MEMORANDUM

Subject: Review of Sourz HVR, Inc. Evaluation of Impacts to Groundwater Resources – Lake County UP 21-10 and IS 21-10

Independent Water Use Analysis and High Valley Aquifer Impact Study –
Sourz HVR Major Use Permit [UP-21-10. Initial Study [IS21-10]

Figure 1. Depth of water (feet bgs) recorded at Well #4 from 1961 to 2020.

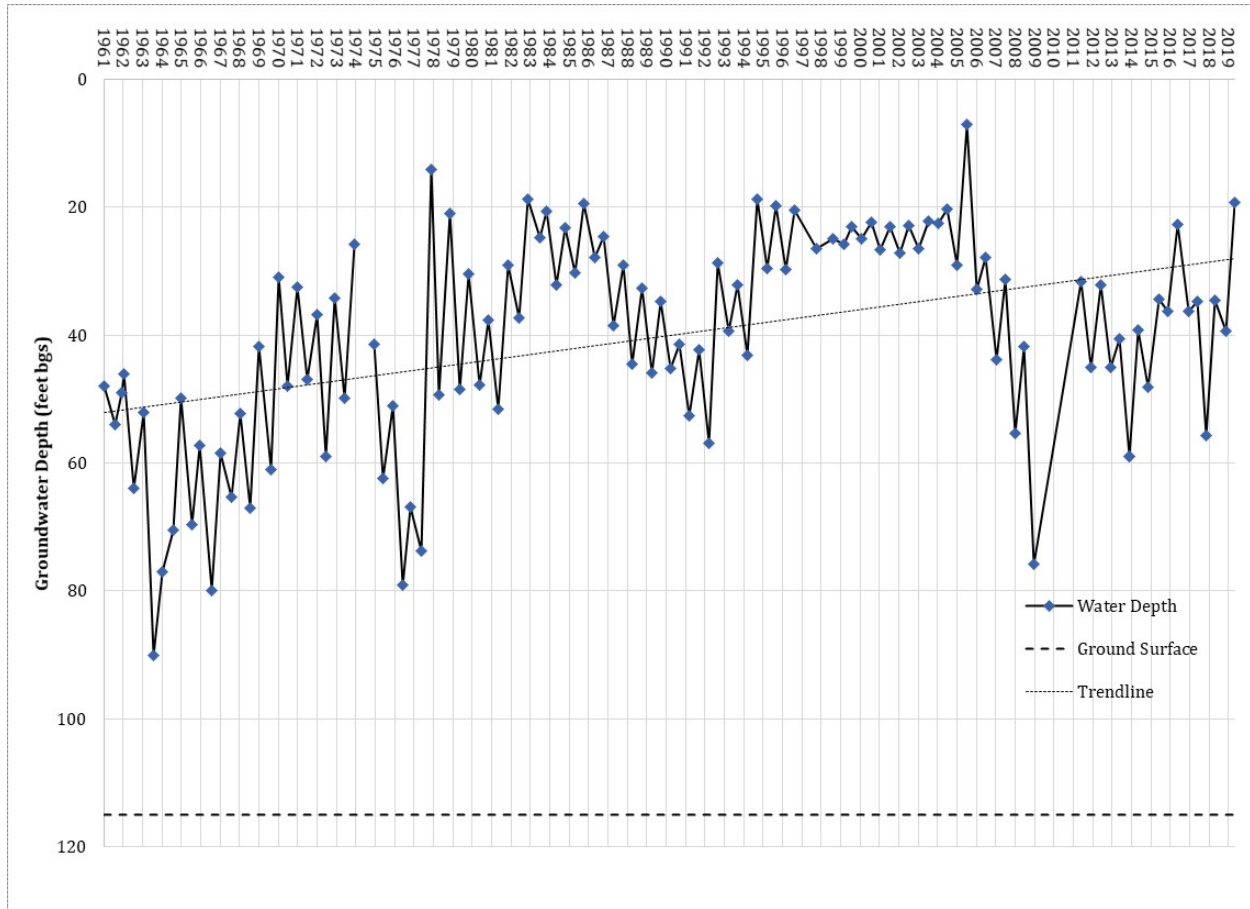
Also not discussed in the IS/MND, TM, or the Revised TM, is that Well #4 is a California Statewide Groundwater Monitoring (CASGEM) Program monitoring well (CASGEM Well ID #35927) that has been used to track and monitor seasonal and long-term groundwater elevation trends in the High Valley Groundwater Basin since 1961. Groundwater elevations in the well have been recorded almost every March and October since 1961. CASGEM identifies the monitoring entity as the Lake County Watershed Protection District. Although the general trend in groundwater depth, in feet bgs, appears to have been increasing since the well was drilled, it has been trending downward over the last 10 to 20 years (Figure 1 through Figure 3). This data, accordingly, contrasts with the data provided in the EBA GAS that seems to suggest the Basin has ample storage and recharge capacity.²
